CLOVERLEAF FILING NO. 2

A REPLAT OF A PORTION OF TRACT B, WOODMOOR PLACER

JOB NO. 25158.01
MAY 7, 2021
SHEET 1 OF 7

DETAIL C

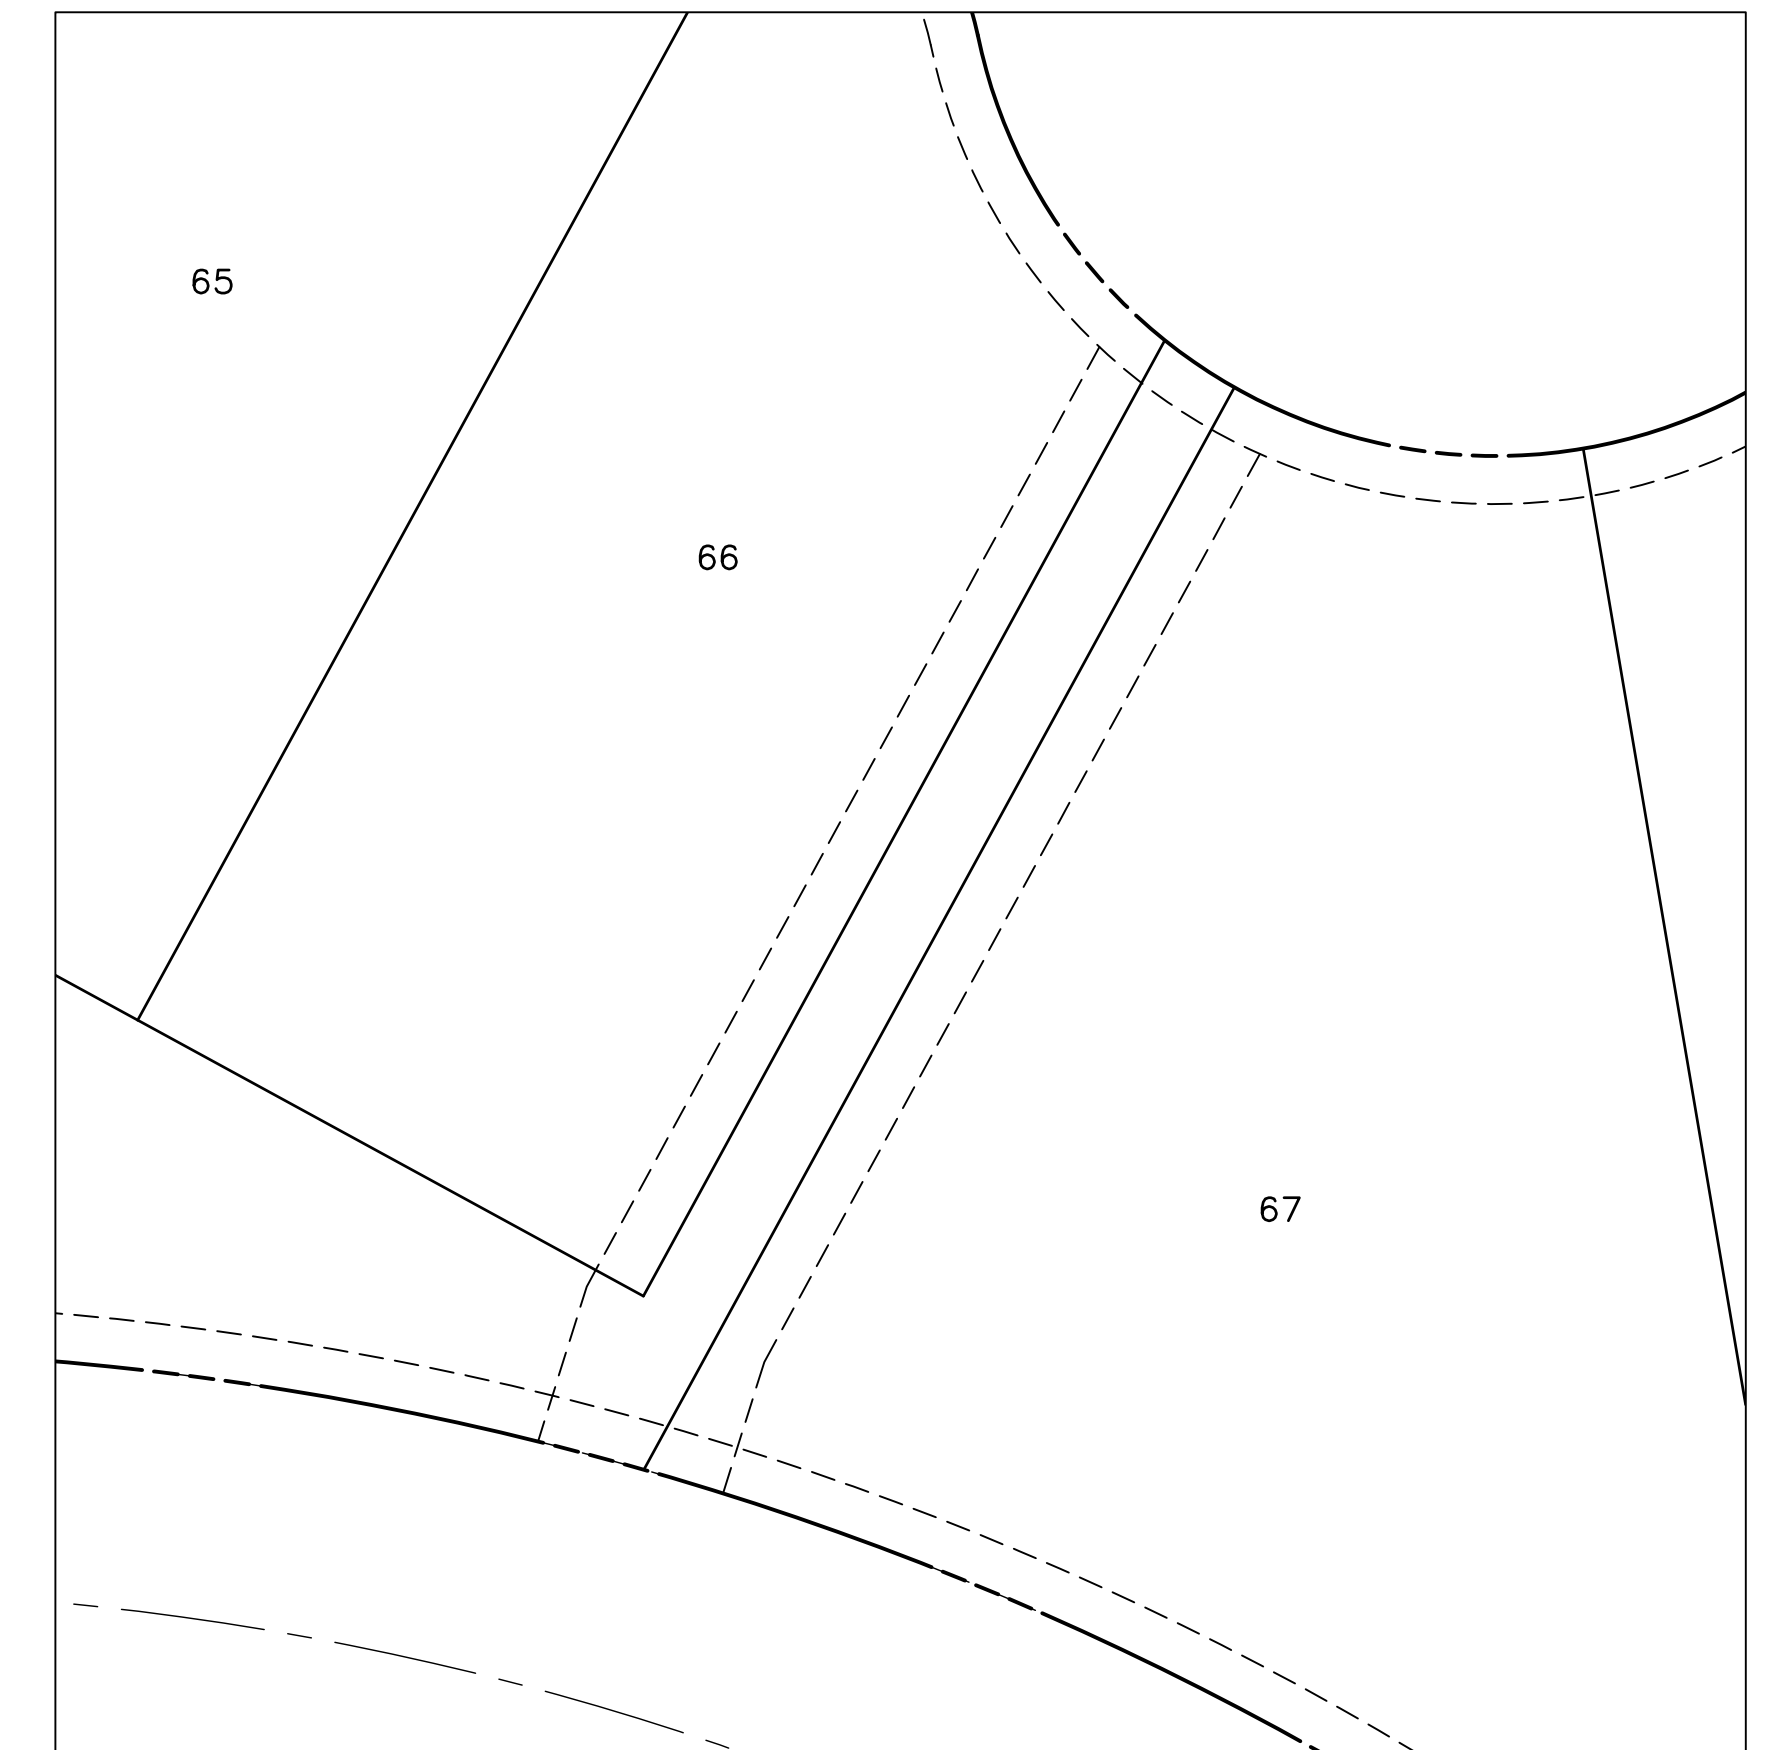
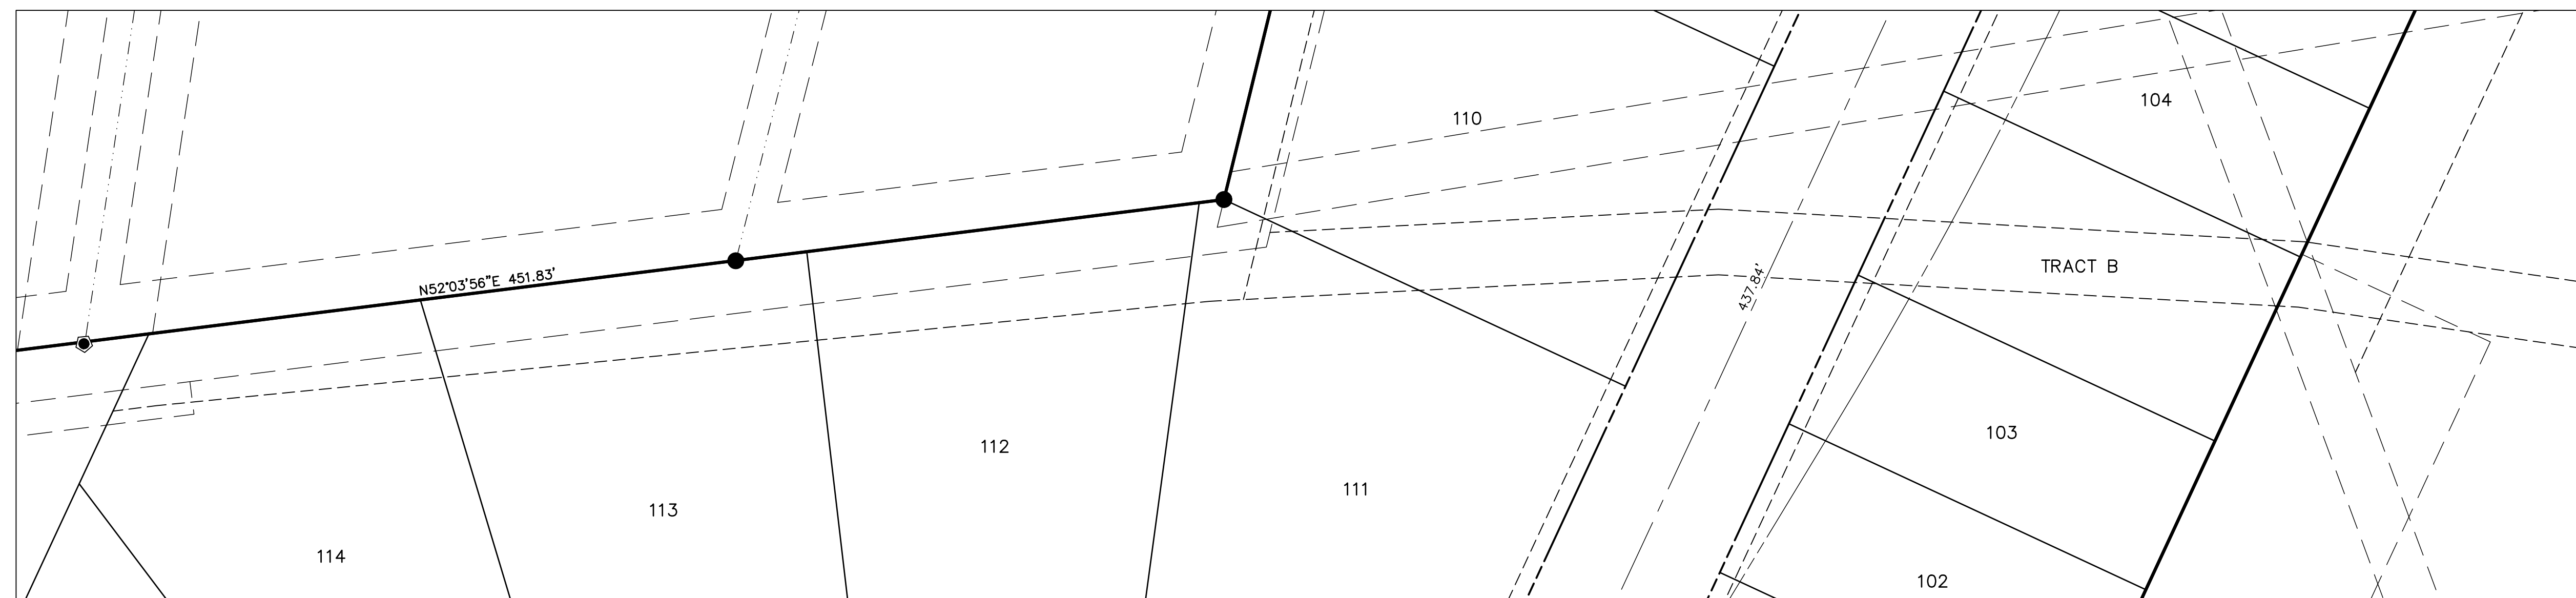
Increase text size so it's legible

Not sure what the specific information this page is trying to convey.
If it's the easements then provide the bearing/distance information for the easements
Will be reviewed on the resubmittal
